# Access Compliance Report

### (Curb Ramps)

| Intersection ID: 24621                  | Main Street: HUGH_FOREST_RD | Cross Street: WALTHAM_LN                | Location: NW           |
| ADA ID: E7A60F884F6B                    | Ramp Type: PerpDiag         | Initial Pass/Fail: Fail                 | Overall Compliance: No |

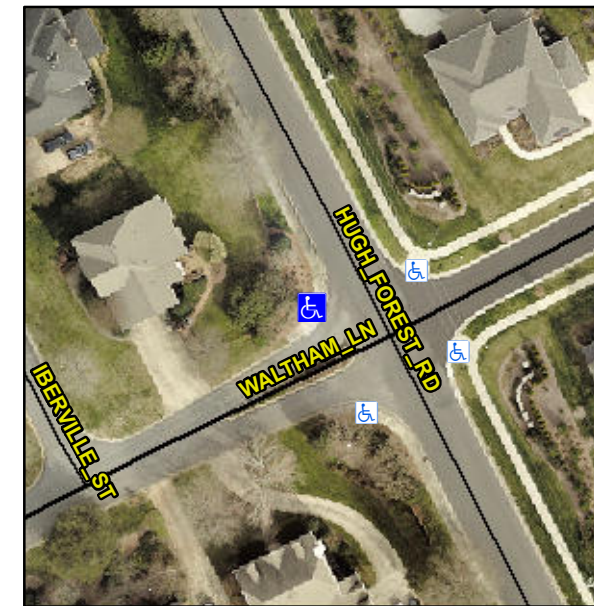
**Not Found, R304.2.2**

| Compliance | Description           | Data | Compliance | Description                 | Data |
|------------|-----------------------|------|------------|-----------------------------|------|
| N/A        | Ramp Length (in)      | 70.0 | No         | Ramp Slope (%)              | 11.1 |

**Remove & Replace Curb Ramp With Two New Directional Ramps or Equivalent.**
